MEMORANDUM

RE: Comments on Vale's Responses to previous MOECC comments on the Port
Colborne Community Based Risk Assessment

At the request of the Niagara District Office, we have reviewed the most recent submission from Vale Canada Limited (Vale) on the Port Colborne Community Based Risk Assessment (CBRA). This report titled "Port Colborne Community-Based Risk Assessment 2014 Update Report" dated September 12, 2014 was prepared by Stantec Consulting Limited (Stantec) to revise the CBRA to address previous comments provided by the Ministry of the Environment and Climate Change (MOECC or the ministry, and formerly MOE). However, a complete submission was not provided to the ministry for review until March 3, 2015. Review comments on the revised Port Colborne Community Based Risk Assessment report are provided in a separate memorandum dated May 17, 2016.

MOECC Figure 1

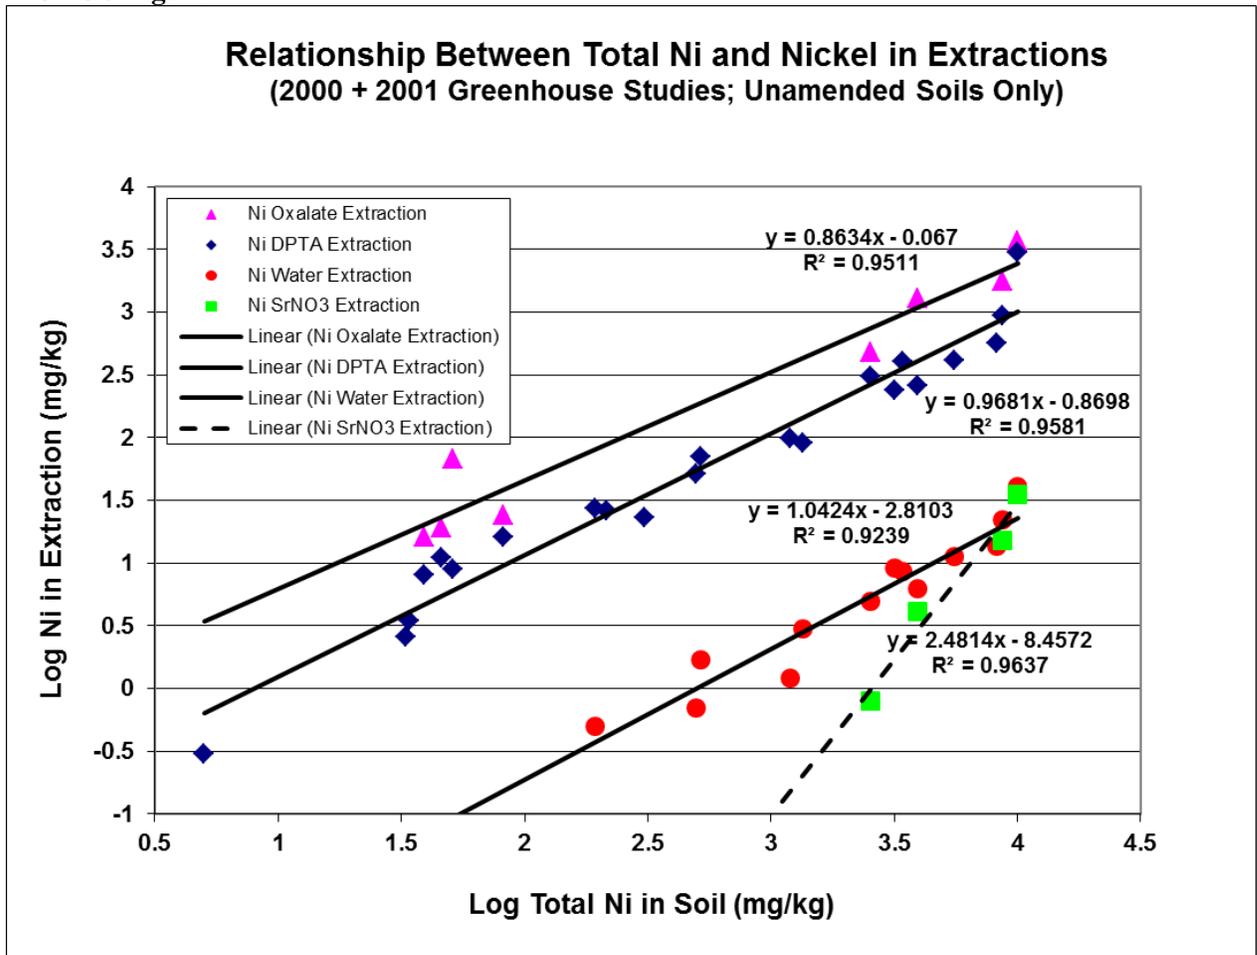
34. **Major Comment 27.** The predictive power of the oxalate, DPTA, or water soil extractions are the same (r^2 ranges from 0.92 to 0.96) between log total Ni in the soil and log total Ni in the extraction (Figure MOECC 1). Higher amounts of Ni were measured in the oxalate and DPTA extractions (higher intercept value) but the slopes are similar so it really doesn't matter what soil extract was used; the relationship between the extracts and the tissue Ni concentration for these extractions will all have similar predictive power. This would likely be apparent in Figure 5-6 if the data was shown as a log-log plot.
